**NATIONAL INSTITUTE FOR HEALTH AND CARE EXCELLENCE**

**Hybrid closed loop systems for managing blood glucose levels in type 1 diabetes**

**Appraisal consultation document**

**Hybrid closed loop systems for managing  
blood glucose levels in type 1 diabetes**

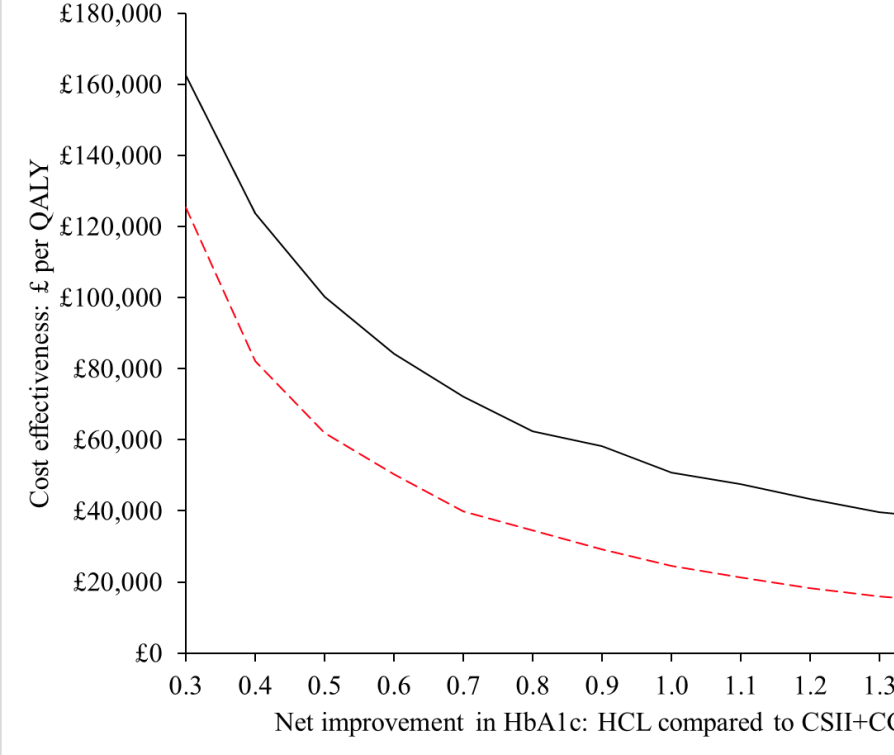
Comment Number	Name and organisation	Stakeholder Comment	EAG considerations
		<p>Using the NHSE adult pilot baseline characteristics data and HbA1c change (-1.5%) results in a large decrease in the ICER from the base case (£12,398 compared with £179k per QALY gained).</p> <p>In light of the [REDACTED], the 1.4 % reduction reported in the ADAPT RCT and the 1.5% reduction reported in the NHS England pilot study, <b>we ask the Committee to consider a mid-point estimate reduction in HbA1c of around 1%</b> (estimated from Figure 1; NB: this threshold analysis chart (fig1) was presented to the committee however exact numbers have not been shared as part of the consultation).</p> <p>Figure 1</p>

Comment Number	Name and organisation	Stakeholder Comment	EAG considerations
		<p data-bbox="667 264 1386 296">Cost effectiveness of HCL vs CSII+CGM by improvement in HbA1c</p>  <p data-bbox="495 472 551 823">Cost effectiveness: £ per QALY</p> <p data-bbox="663 983 1386 1015">Net improvement in HbA1c: HCL compared to CSII+CGM</p> <p data-bbox="495 1230 1189 1262"><b>Additional factors likely to reduce the ICER further are:</b></p> <ul data-bbox="495 1294 1386 1383" style="list-style-type: none"> <li>• Uncaptured disutilities in the model for hypoglycaemia, mental burden and patient and carer anxiety, the true ICER is likely to be lower than this.</li> </ul>
